RE: **Lot 12 Block 9 Unit 18 Volcano Cliffs SAD 228**  
**6520 Papagayo NW**  
**Grading and Drainage Plan**  
**Engineers Stamp Date 4/17/17 (D10D003I12)**

Based upon the information provided in your submittal received 4/18/17, this plan cannot be approved for Grading Permit until the following comments are addressed.

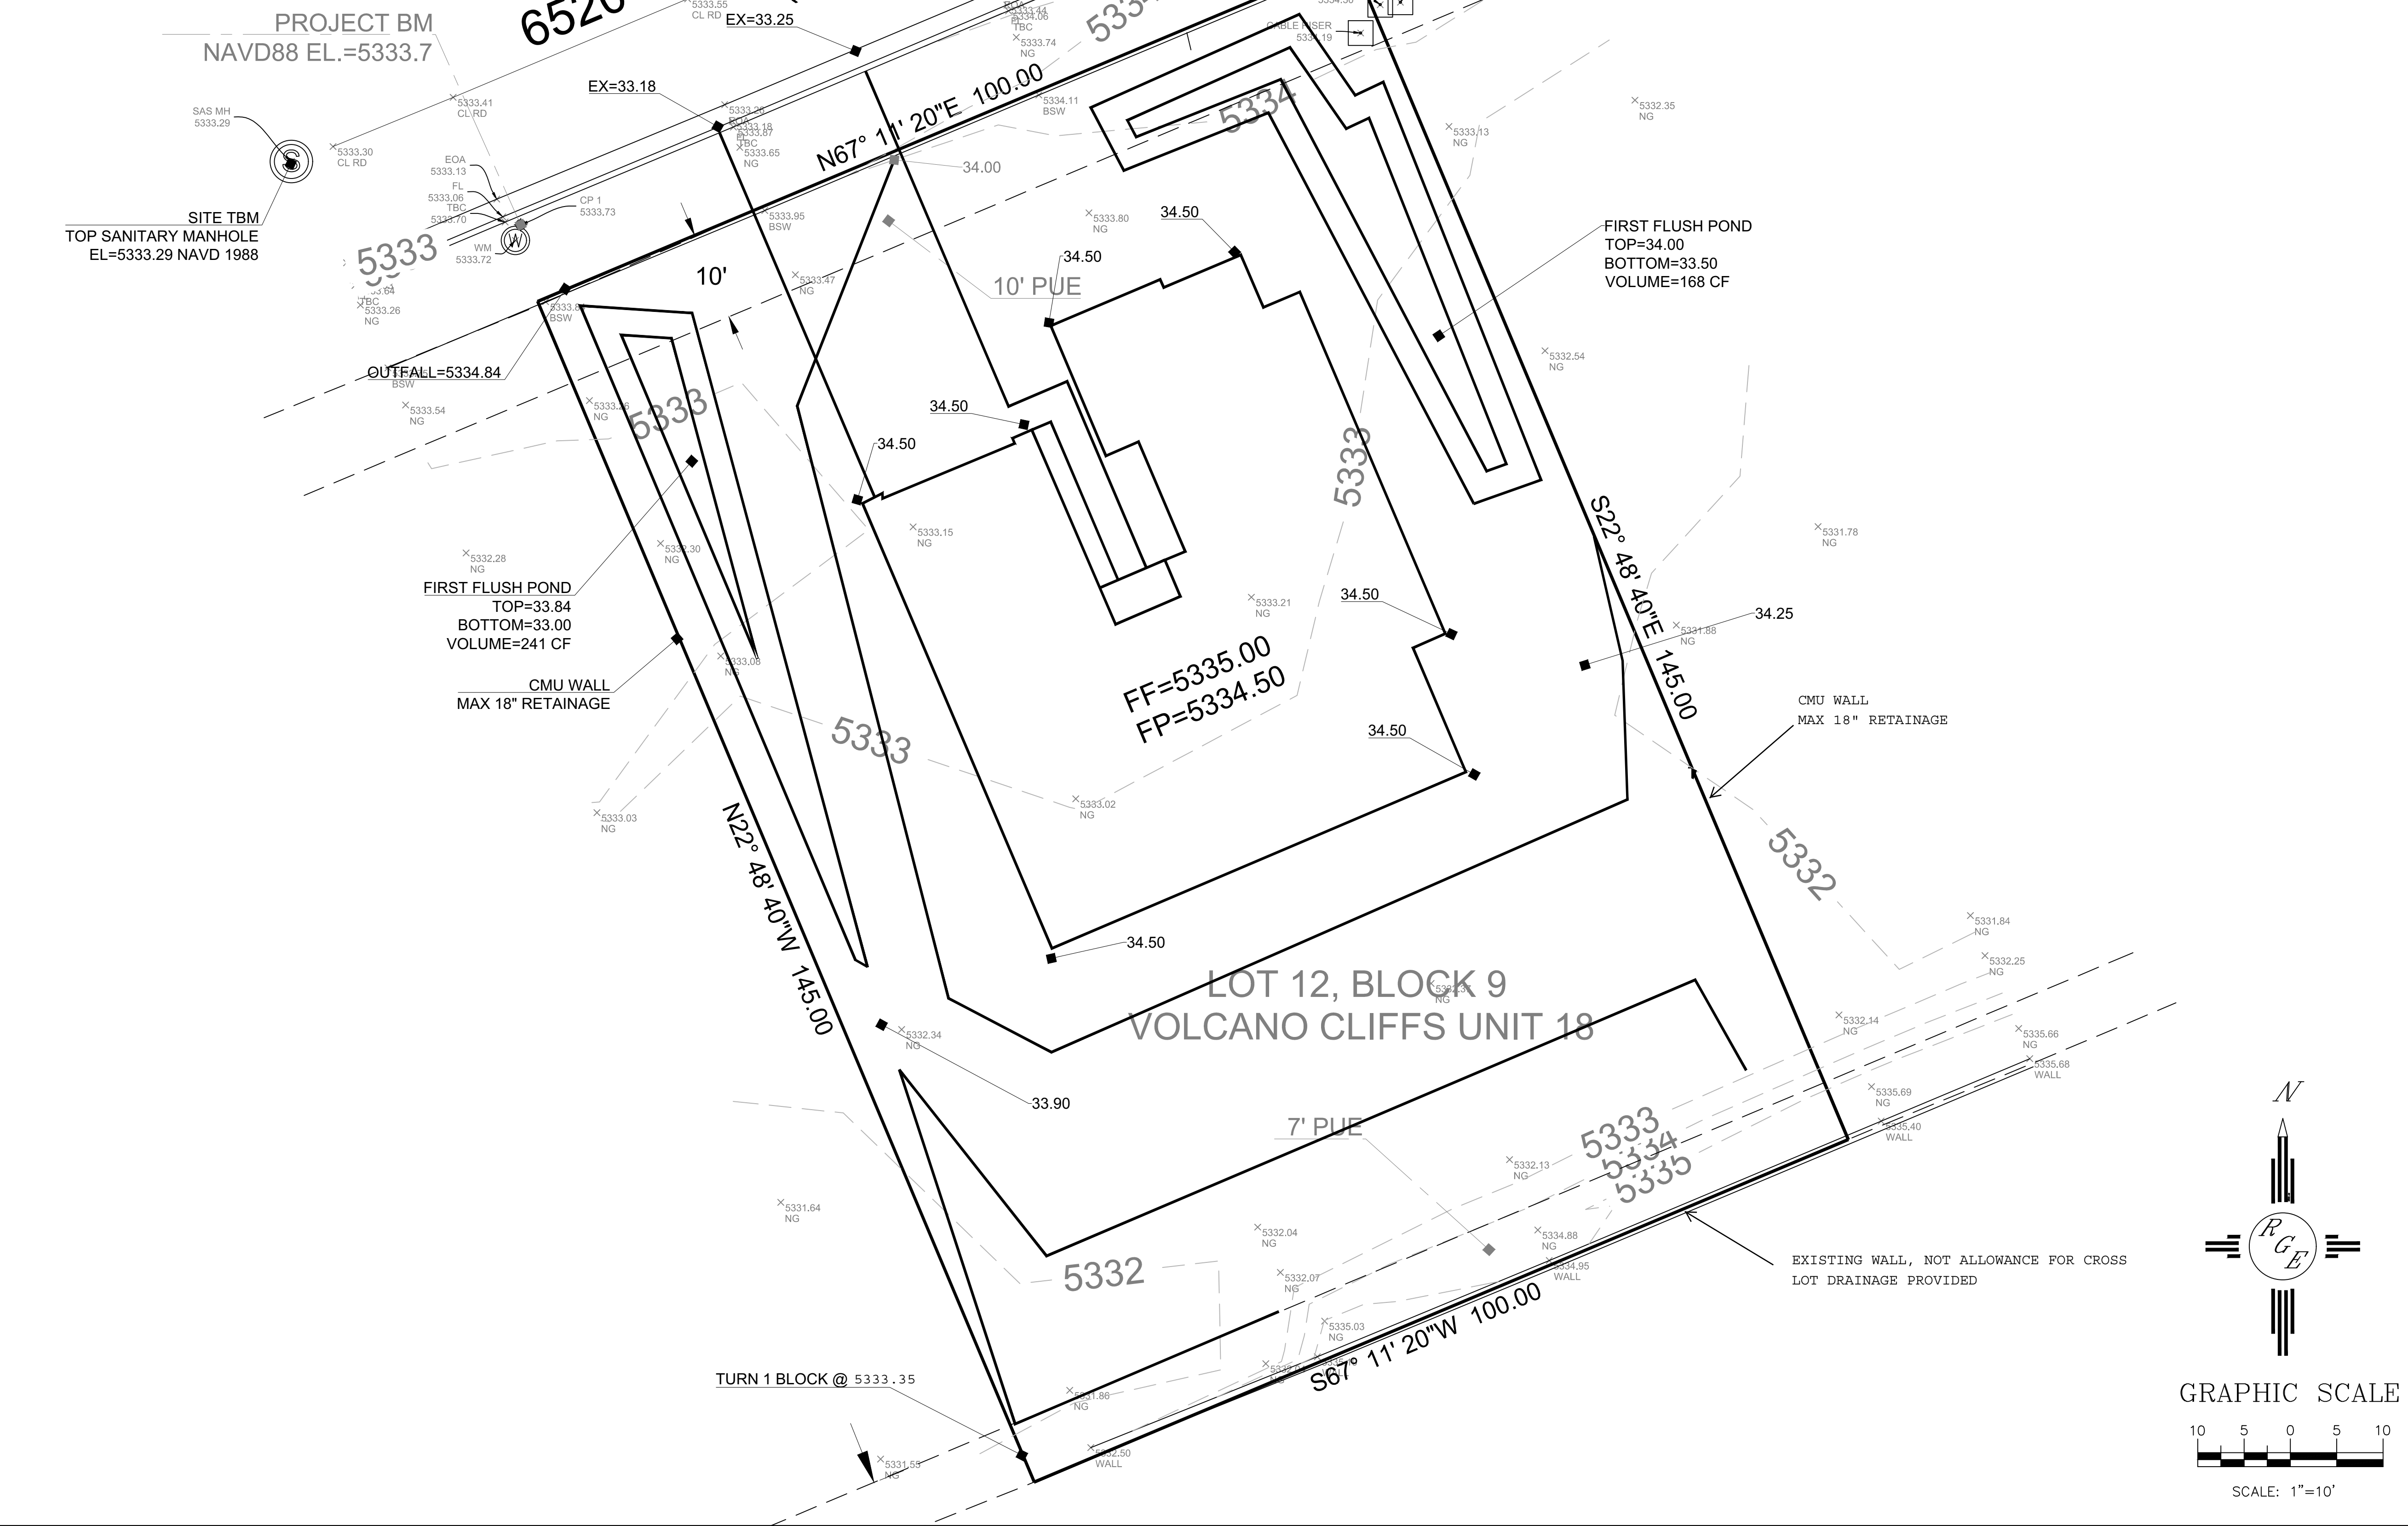
- Provide an opening in Garden Wall at the SW corner.
- Provide the water quality ponds in the rear yard where cross lot flow is to be provided. Flows do not need to leave front yard.
- Provide calculations for the openings in the walls.
